HISTORIC AND DESIGN REVIEW COMMISSION

Agenda Item No: 20

HDRC CASE NO: 2016-020
ADDRESS: 139 E COMMERCE ST
141 E COMMERCE ST
143 E COMMERCE ST
106 RIVERWALK
145 E COMMERCE ST
147 E COMMERCE ST
149 E COMMERCE ST
151 E COMMERCE ST
LEGAL DESCRIPTION: NCB 106 BLK LOT 27
NCB 106 BLK LOT 28
NCB 106 BLK LOT 29 & 30
NCB 106 BLK LOT 31
ZONING: D HS RIO-3, D RIO-3
CITY COUNCIL DIST.: 1
LANDMARK: Commercial Building
APPLICANT: KHI, Inc
OWNER: Burgos LP / Uriarte LP
TYPE OF WORK: Demolition with new construction of a mixed use, mid-rise tower
REQUEST:

The applicant is requesting conceptual approval to:

1. ILLUSTRATE THE MASSING AND SETBACKS

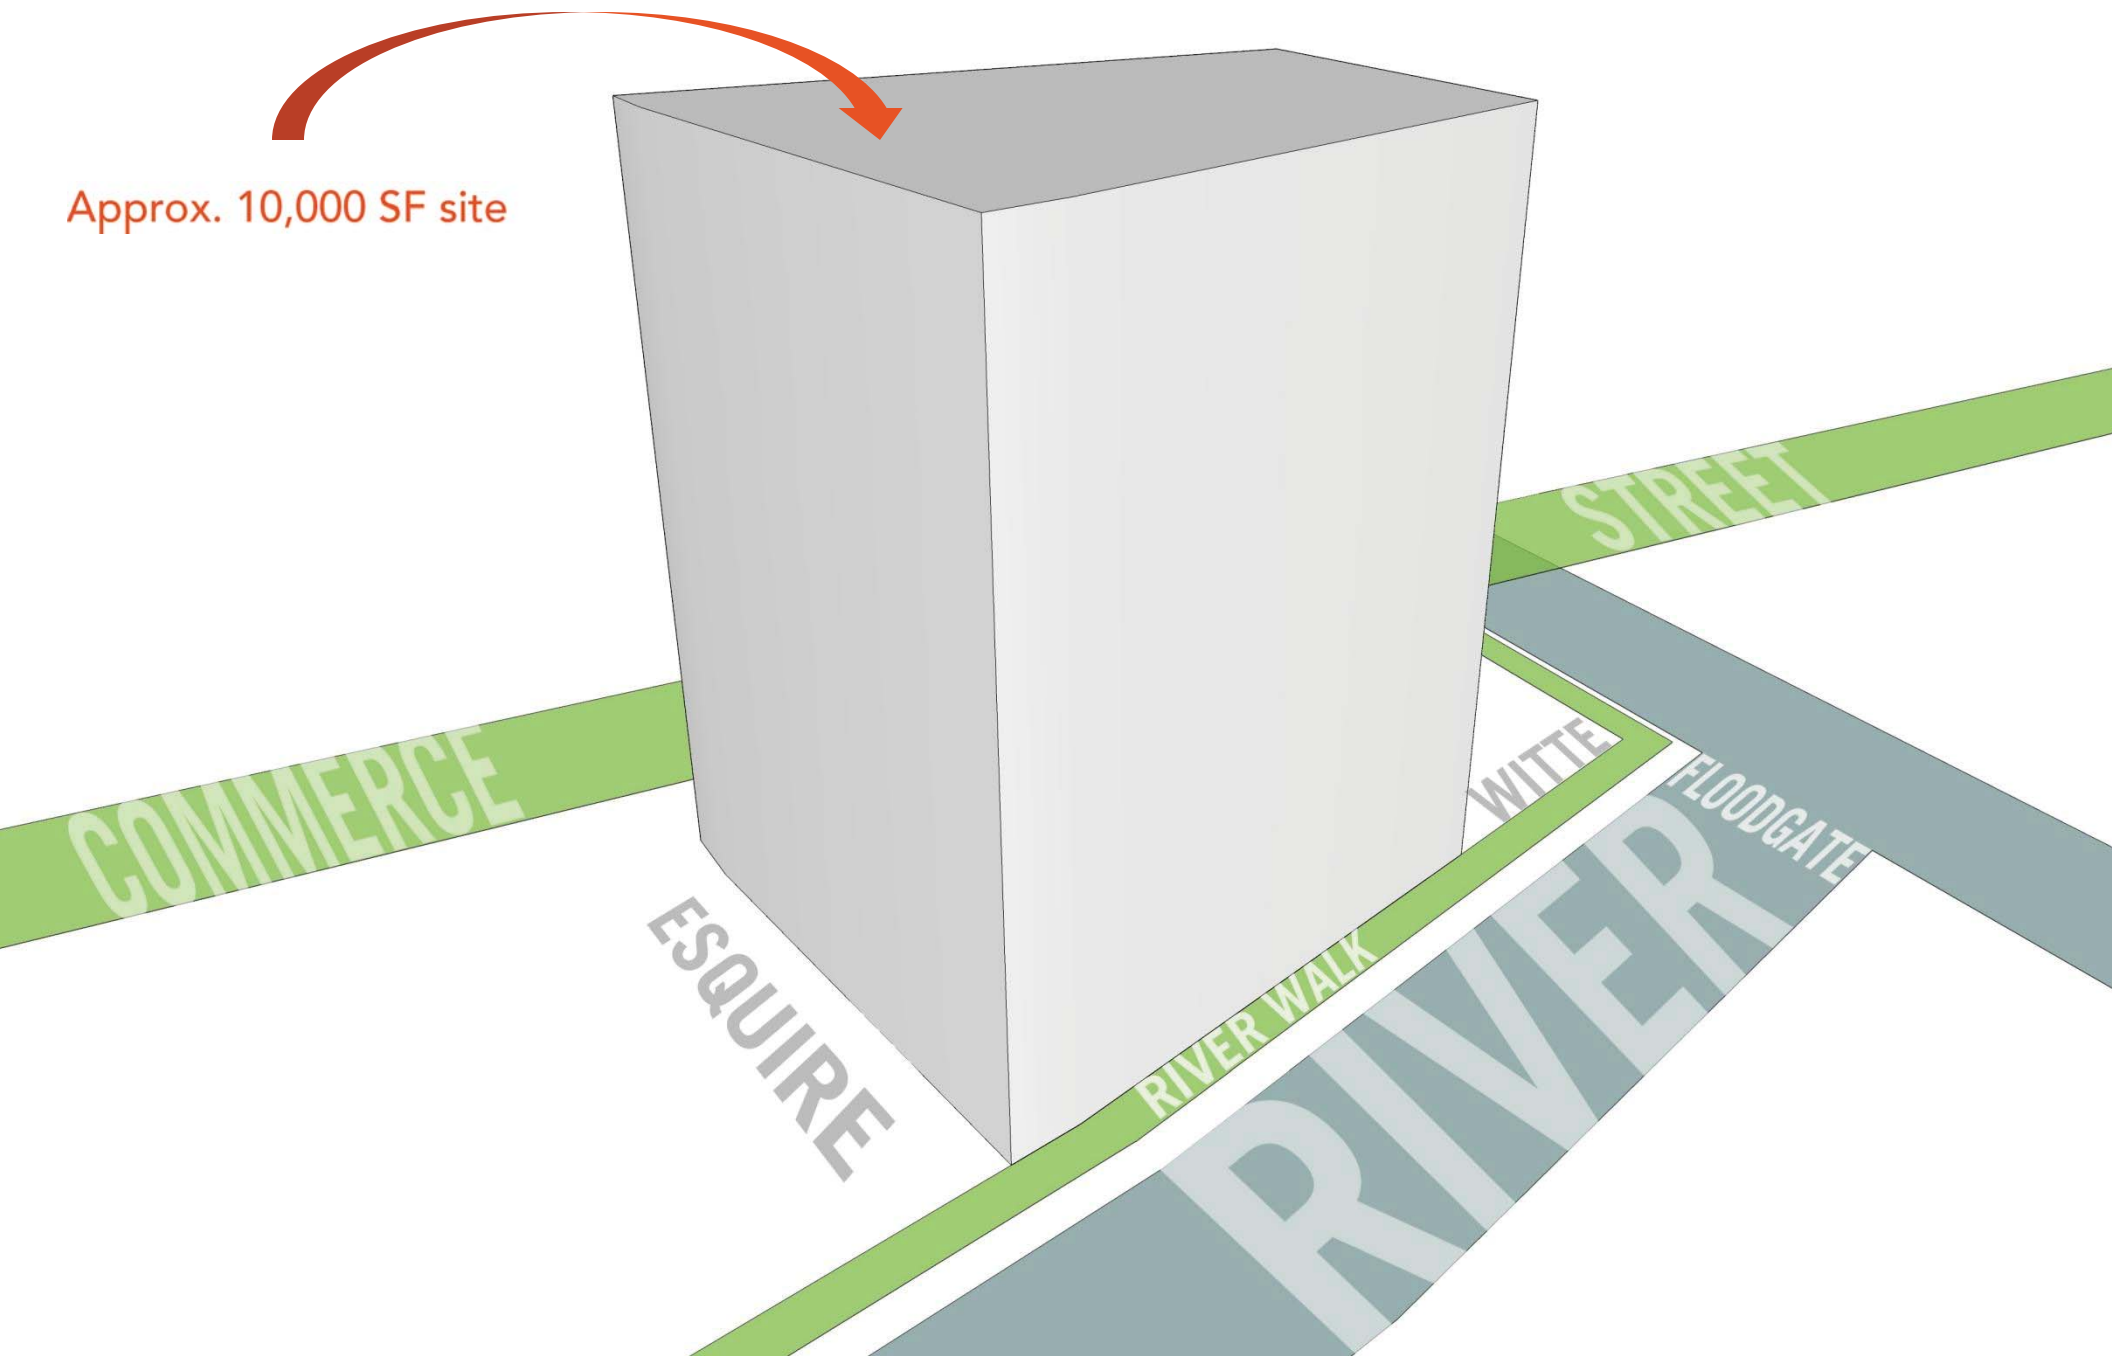
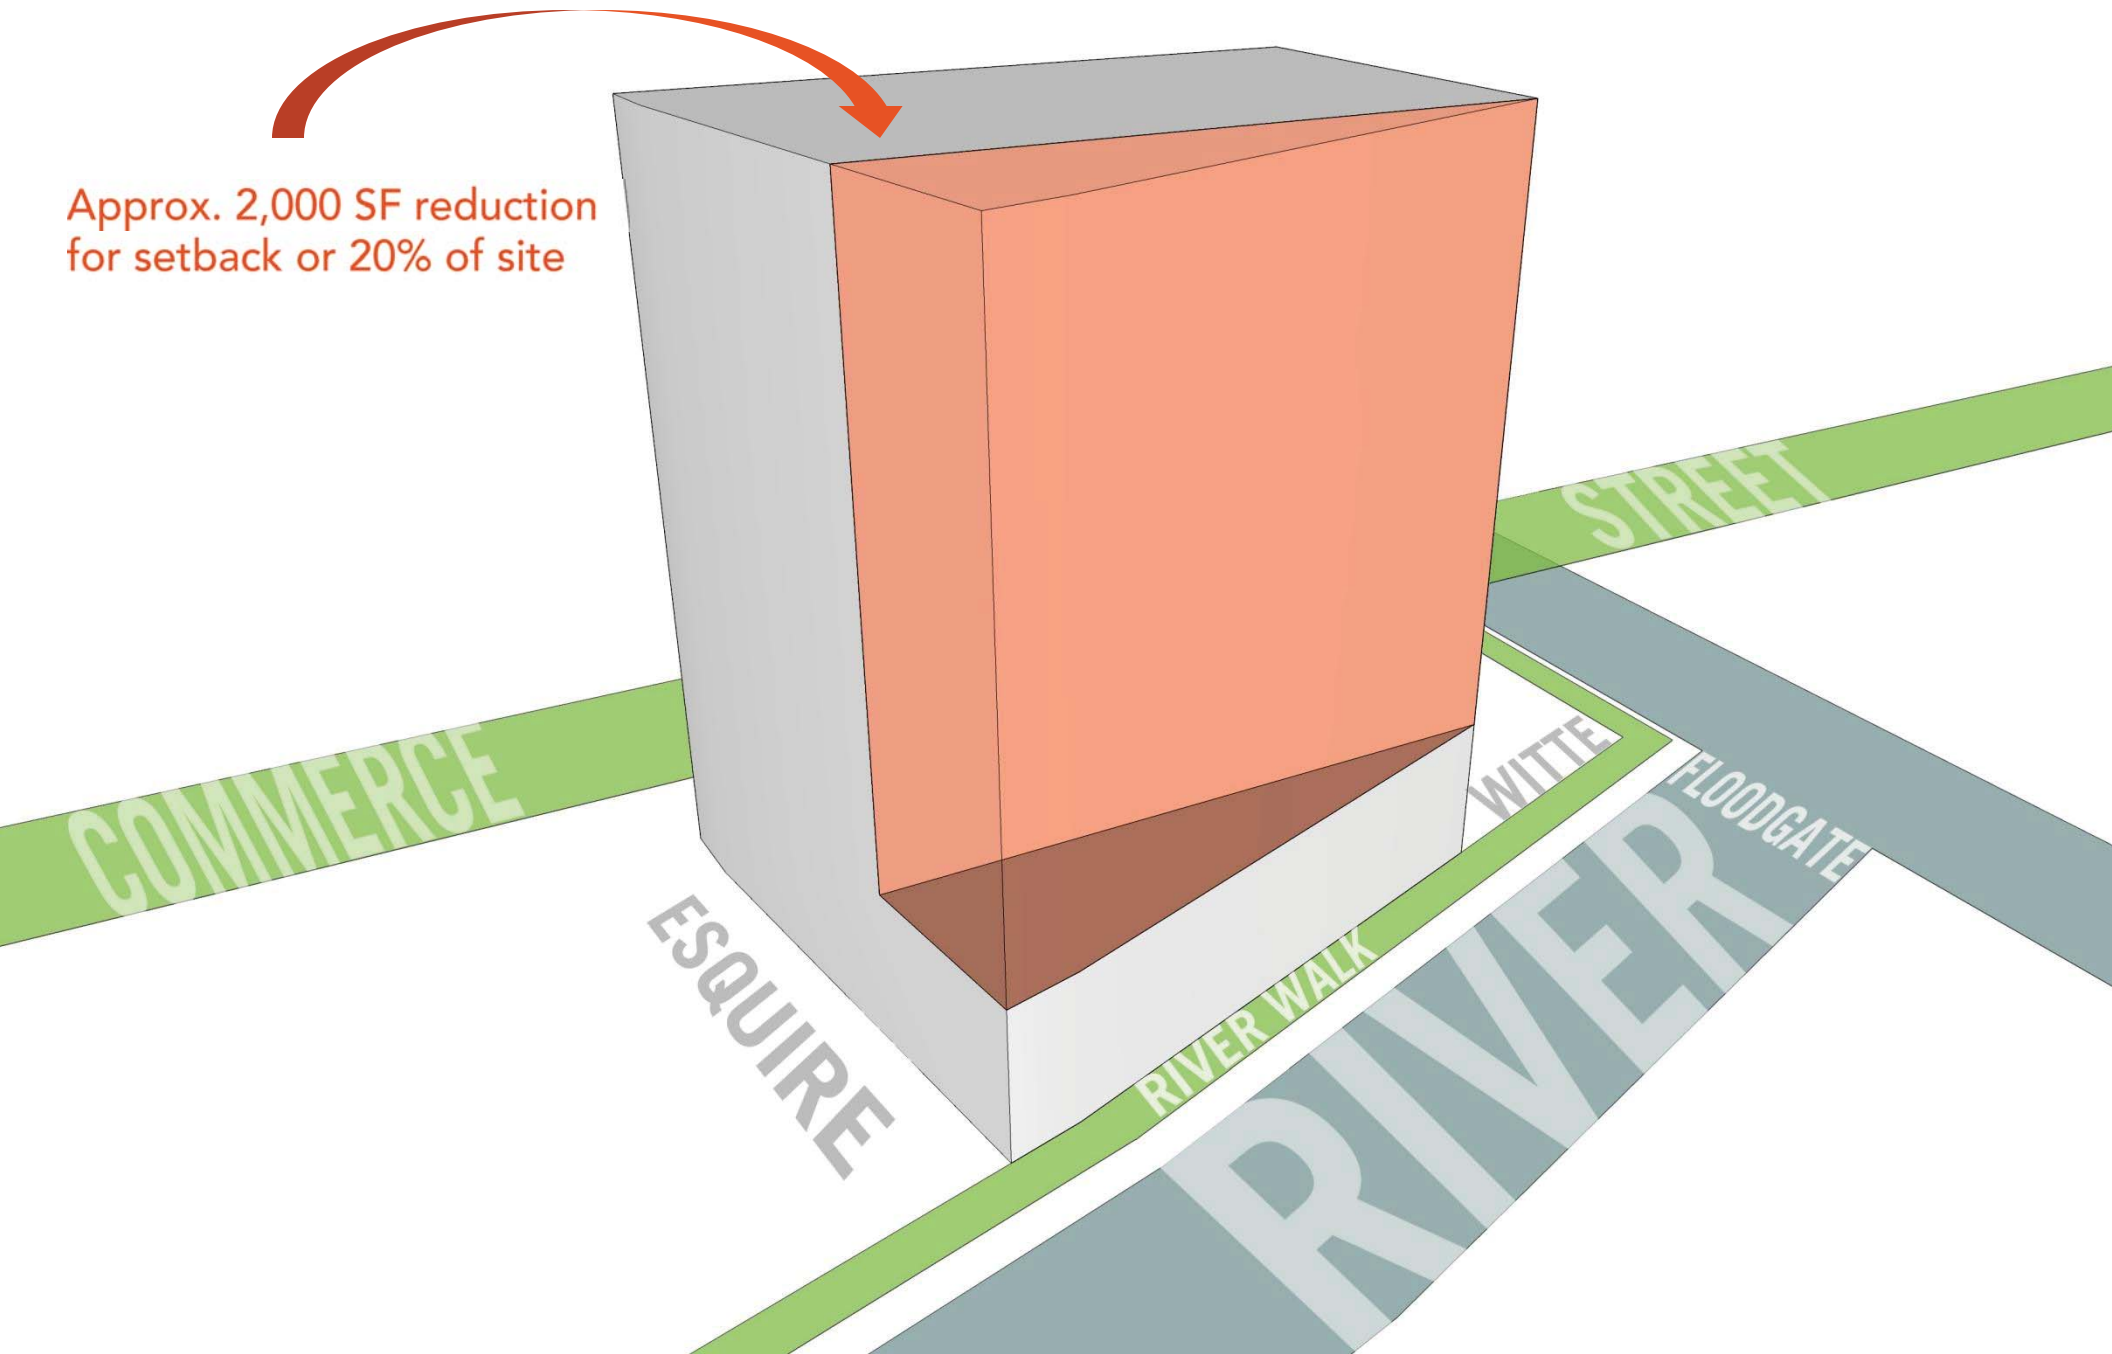
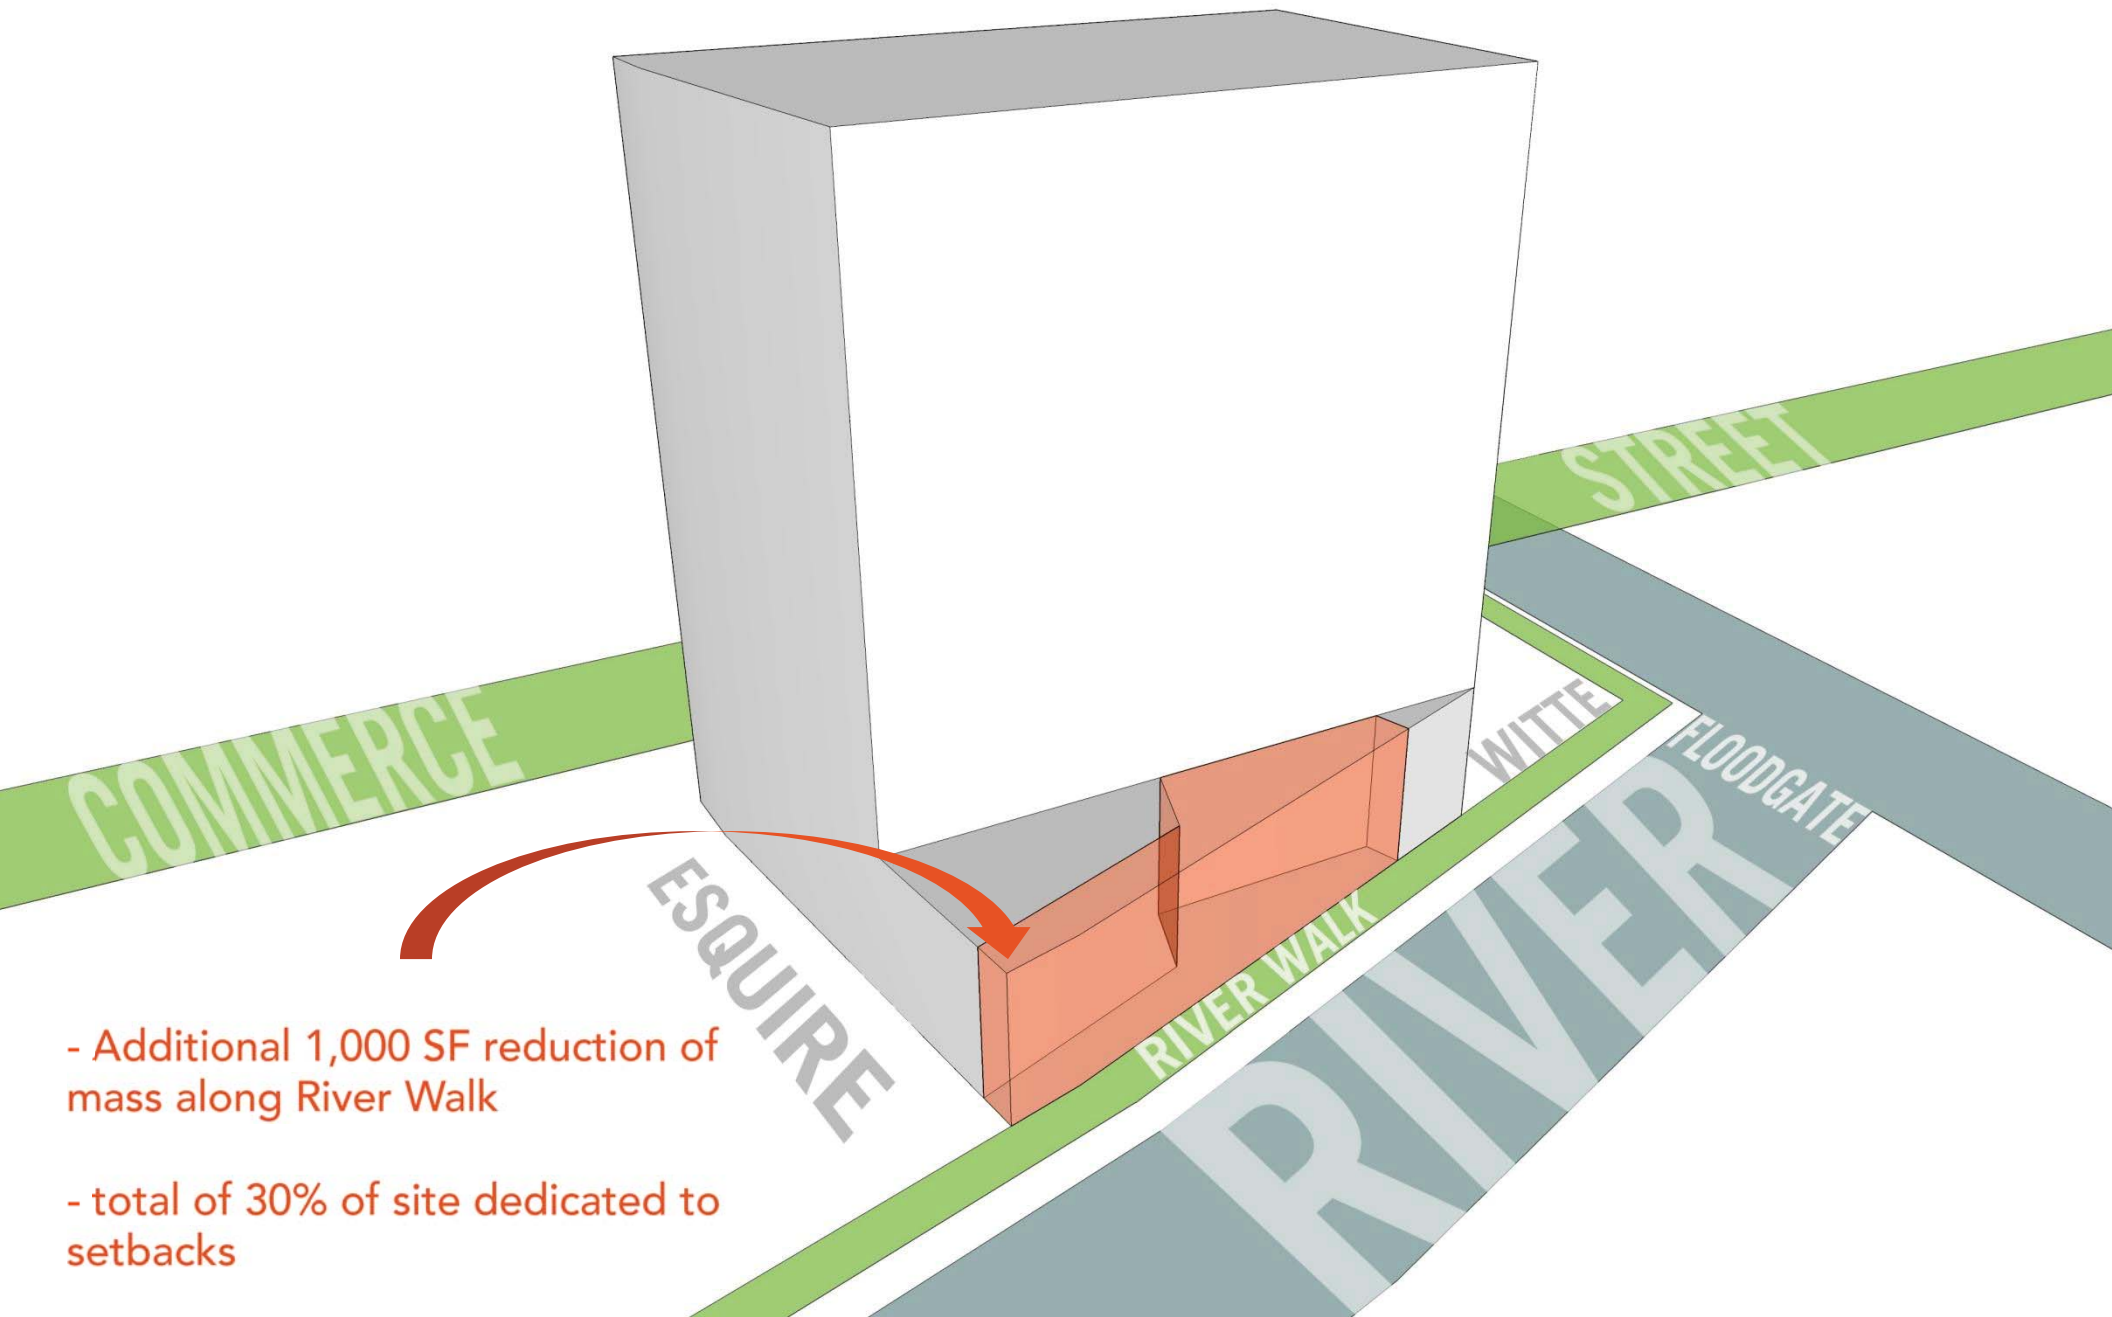
- a. This request was reviewed by the Design Review Committee on January 5, 2016, where committee members expressed concern over the existing stone walls that hold historic characteristics, asked questions regarding parking, the introduction of pedestrian traffic from E Commerce to the Riverwalk through the site, the connection of new paving materials to existing Hugman materials, how the existing Witte Building's façade might be translated into that of the new construction and noted that overall the proposal was attractive. At an HDRC hearing on March 16, 2016, concern as expressed regarding the treatment of the river level and the extent of the proposed removal of historic stone walls. The item was referred back to the Design Review Committee which met and reviewed this request a second time on March 22, 2016. The applicant provided updated drawings which address the stated concerns included the re-use of additional stone elements at the river level, creating additional articulation at the east and west facades, clarification on the parking garage driveway design, and an illustration that shows the alignment of canopies along Commerce Street.

Approx. 10,000 SF site

Approx. 2,000 SF reduction
for setback or 20% of site

- Additional 1,000 SF reduction of mass along River Walk

- total of 30% of site dedicated to setbacks

Additional 5,000 SF of leasable street
and river level retail created

Additional 2,000 SF of site
set aside for public space
accessible from both River
Walk and Commerce
Street
